Delegated Planning Committee Meeting

Tuesday 25 May 2021
Commencing at 6pm

Application:	PA1531815
Address	16-18 & 20 Sargood Street Altona
Proposal:	Application under section 87A of the Planning and Environment Act 1987 to amend a planning permit for buildings and works associated with the construction of a six storey building comprising retail premises, office, dwellings and partial basement car parking, use of the land for retail premises and office, a reduction in the car parking requirements at Clause 52.06 of the Hobsons Bay Planning Scheme and a waiver of the loading/unloading requirements at Clause 52.07 of the Hobsons Bay Planning Scheme in accordance with the endorsed plans

Planning Permit No PA1531815 Amendment Pursuant to Section 87A of the Planning & Environment Act 1987

Drawing Number A3.01 Rev. END

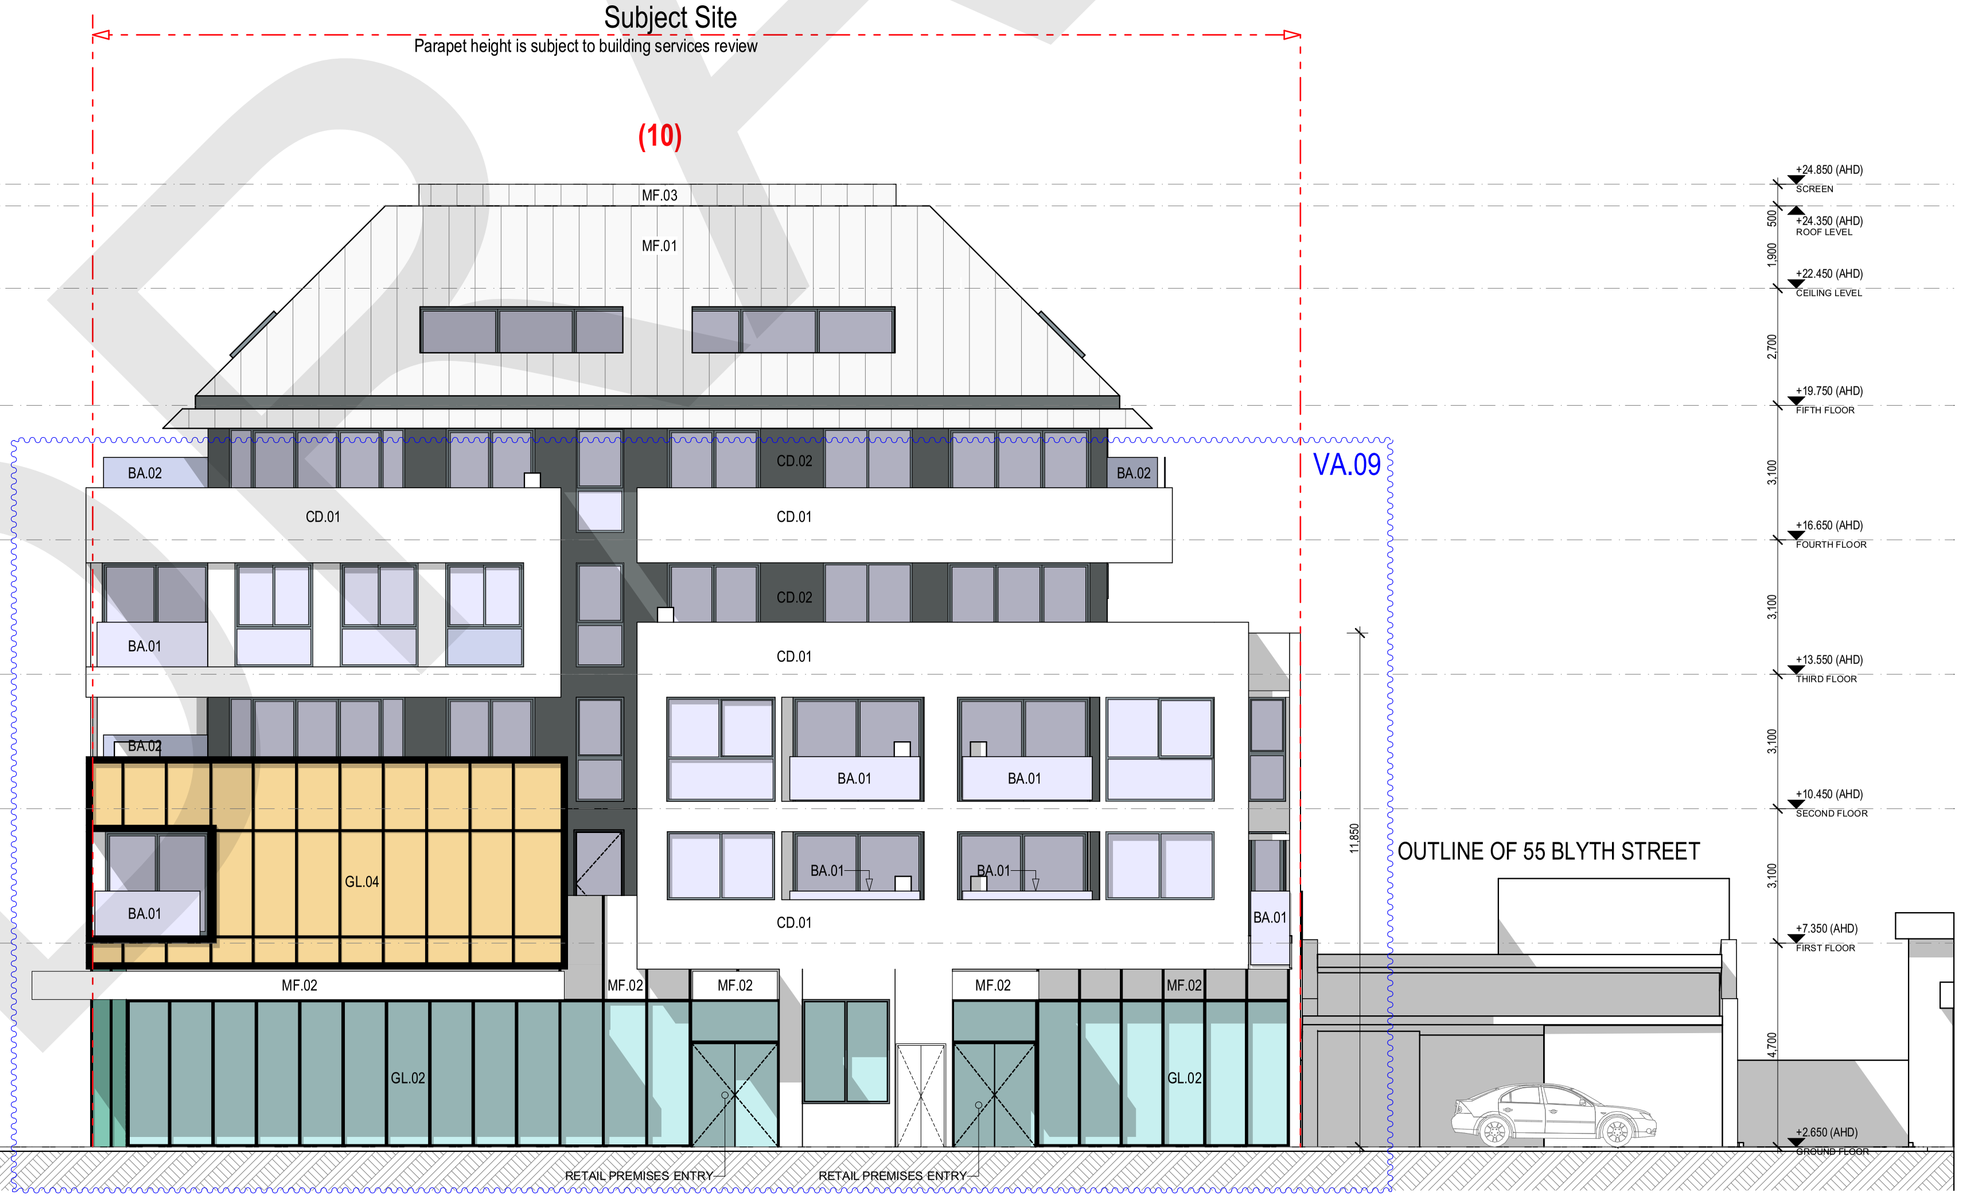
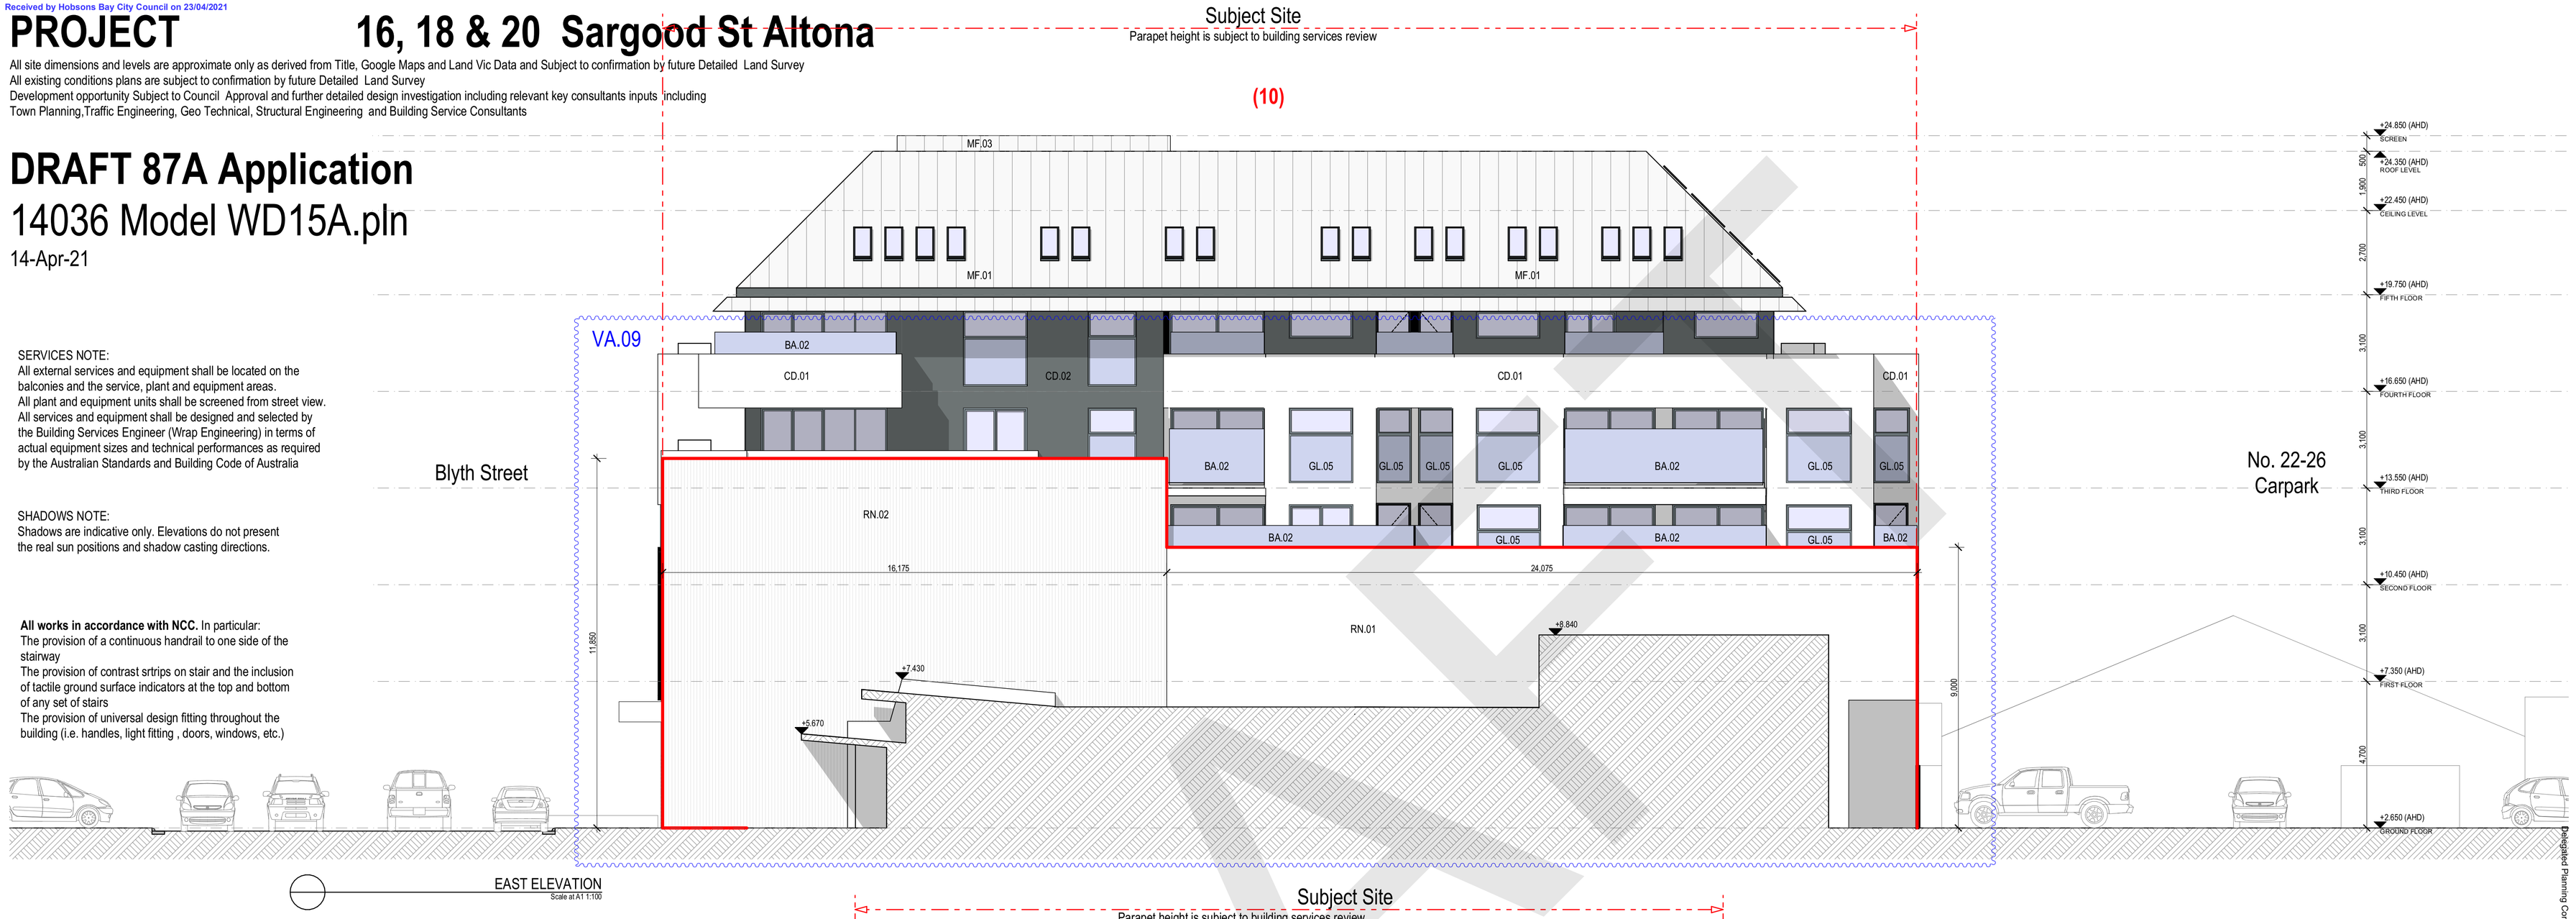
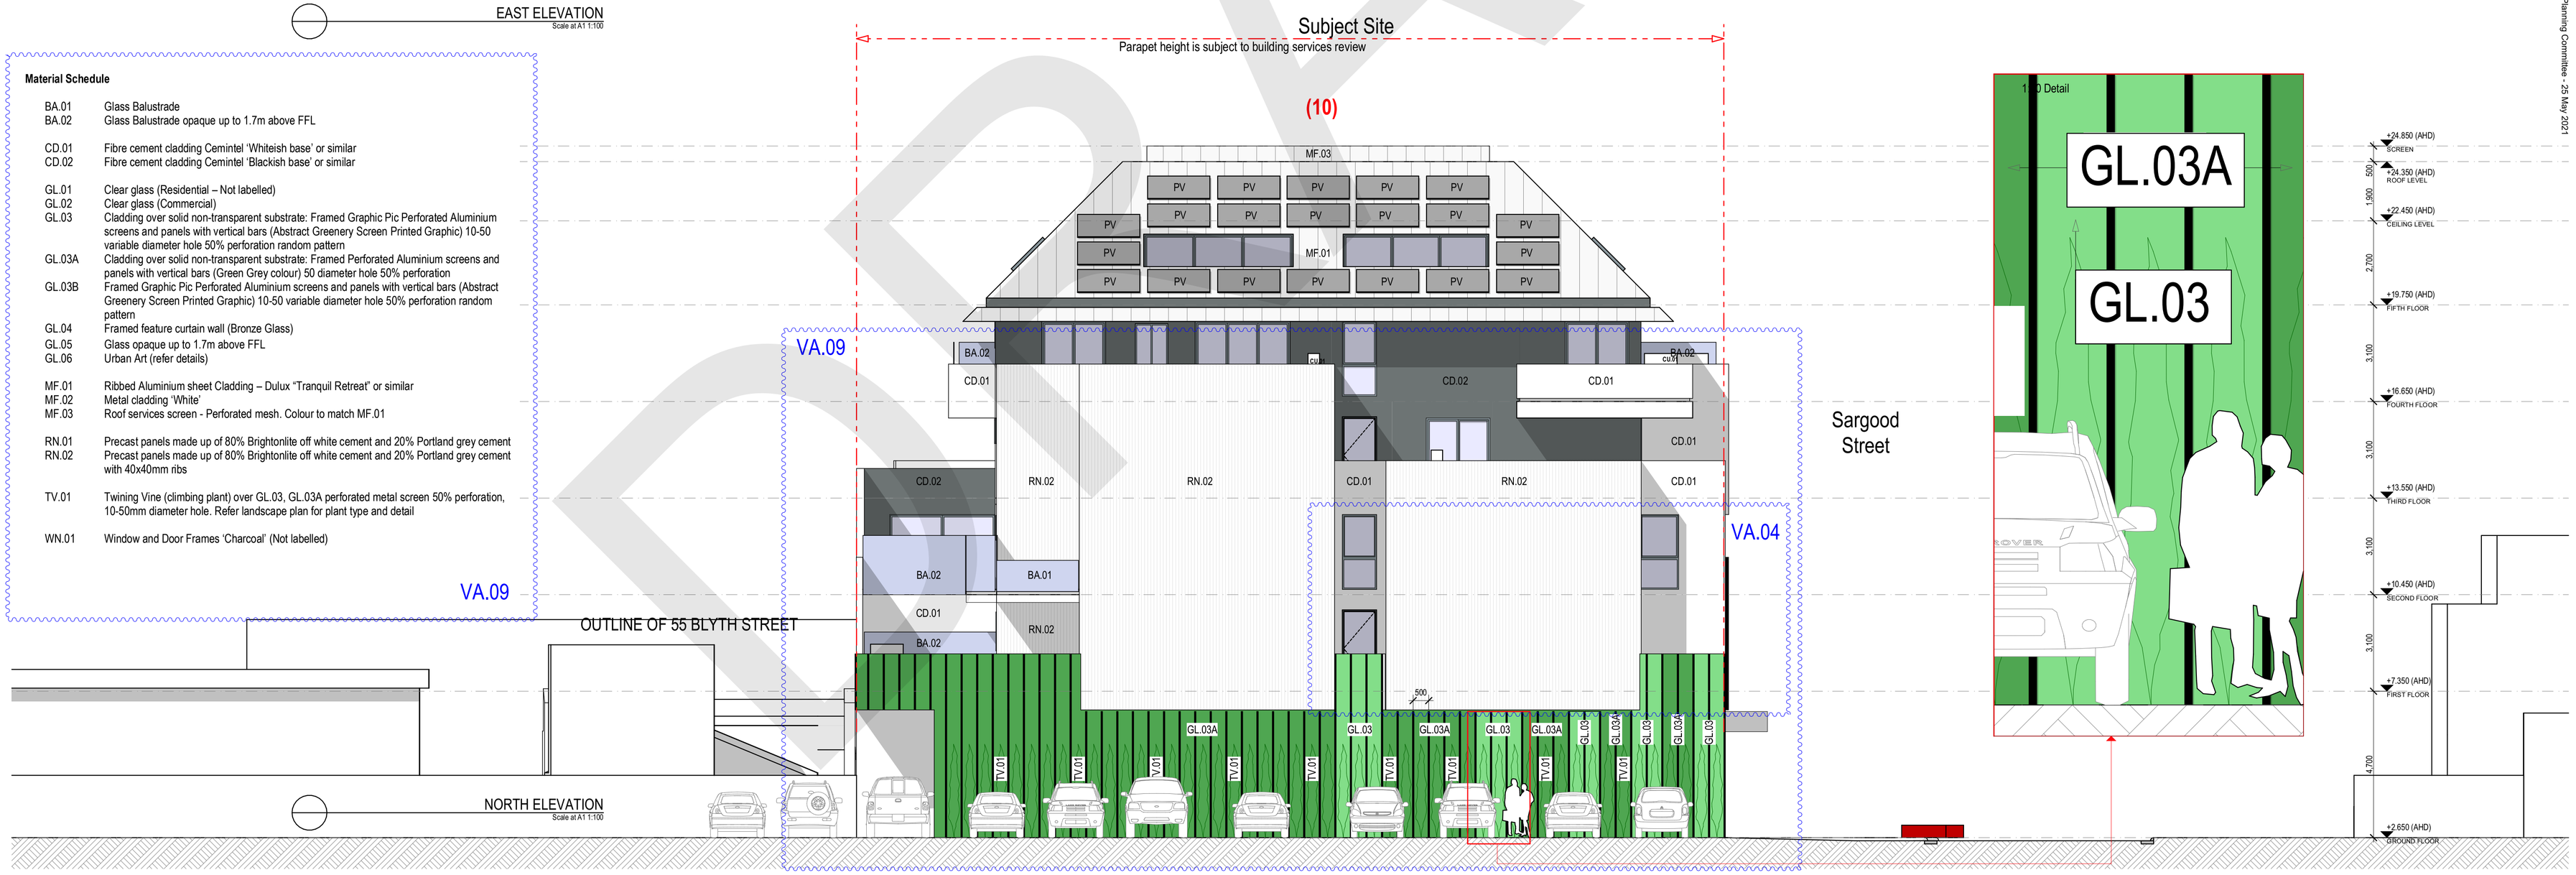
The amended building form as shown in Figure 1 below is essentially the same as the approved design shown in Figure 2. The external built form, particularly as it presents to the nearest residential properties 23m from the site to the west at 57 Blyth Street, has not been significantly altered with the height and length of boundary walls to the west and east maintained in line with the approved development. The east facing balconies of apartments 205 and 206 have also been setback from the east boundary which is acceptable as it will assist in maintaining equitable development rights for the neighbouring property. The proposed building materials and finishes were discussed at the compulsory conference with changes agreed to in relation to some cladding which form part of the draft amended permit

One change which will be addressed by conditions is the use of horizontal louvered screens on balconies to prevent overlooking. While opaque glass balustrades have been approved the applicant has agreed to introduce the louvered screens which will have the same effect of preventing overlooking while improving internal amenity to the apartments by minimising the 'fish bowl' affect of an enclosed space. This requirement is included in the draft conditions -.

(b) The fibre cement cladding referenced as CD.01 and CD.02 replaced with ribbed aluminium sheet cladding (light grey metal finish- 'Dulux tranquil retreat') or similar more durable/ robust material.

(c) Opaque glass balustrades referenced as BA.02 on the plans replaced with horizontal angled louvered screens or other similar treatment to the satisfaction of the Responsible Authority.
